**ADDENDUM #4**

**September 26, 2017**

**UNC Charlotte Sycamore Hall Renovation  
Charlotte, North Carolina  
SCO #16-12735**

<p><small>BULLETIN DRAWING TITLE:</small></p> <p>CHILLED WATER BUFFER TANK SCHEDULE</p>	<p><small>PROJECT NUMBER</small> 1610</p> <p><small>DRAWING NUMBER</small></p> <p style="font-size: 2em; font-weight: bold; text-align: center;">BDM-4</p> <p><small>DATE:</small> 09/25/17</p>
---	---

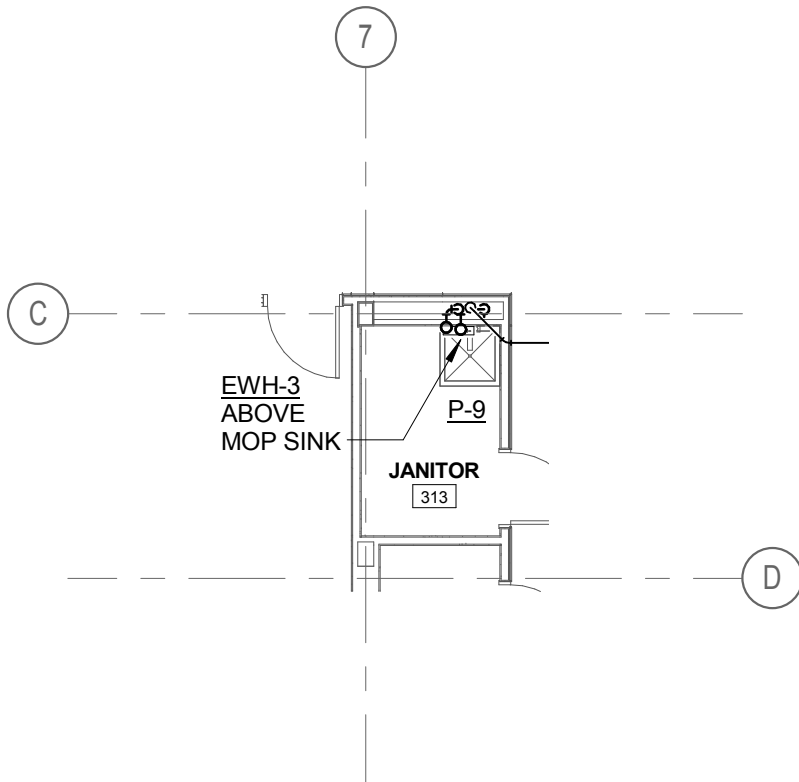
**PURPOSE OF DRAWING:** TO PROVIDE SPECIFICATION FOR CHILLED WATER BUFFER TANK

UNIT DESIGNATION	BT-1	
SERVICE	CHILLED WATER	
TYPE	DIAPHRAGM	
MANUFACTURER	TACO	
MODEL NUMBER	BTL0500F04-125N	
TANK VOLUME (GALLONS)	500	
EMPTY WEIGHT (LBS)	1160	
HEATER KW	7.5	
HEATER VOLTAGE	460/3	
HEATER AMPS	9.4	
<p><b>NOTES:</b></p> <ol style="list-style-type: none"> <li>1. APPROVED EQUALS: LOCHINVAR, WESSELS</li> <li>2. ASME, CARBRON STEEL CONSTRUCTION</li> <li>3. 2" ARMAFLEX INSULATION WITH ALUMINUM JACKET</li> <li>4. PROVIDE IMMERSION TYPE HEATER FOR FREEZE PROTECTION.</li> </ol>

BULLETIN DRAWING TITLE:	PROJECT NUMBER
<b>THIRD FLOOR</b>	<b>1610</b>
<b>PLUMBING</b>	DRAWING NUMBER
	<b>BDP-1</b>
	DATE: 09/25/17

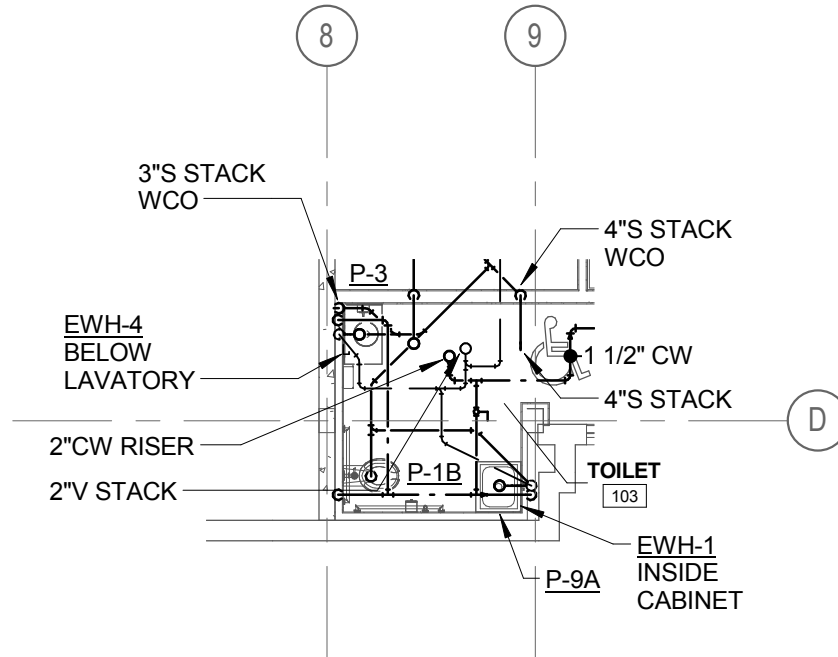
<b>#</b>	<b>RFI/ Substitution Request</b>	<b>Response</b>
34	Restroom on first floor toilet tag (P-1A) is scheduled as a wall hung; however, there is no plumbing wall to support fixture. Should this become a floor mount fixture as shown and if so what is the specification?	Refer to attached bulletin drawings; this is a P-1B fixture.
35	The janitors sink in room 313 is not tagged. Does it need to be a P-9 or is it existing to be relocated?	The janitor's sink in room 313 is a new P-9 fixture. See attached bulletin drawings.

**PURPOSE OF DRAWING:** ADD TAG TO MOP SINK IN JANITOR'S CLOSET - 313.
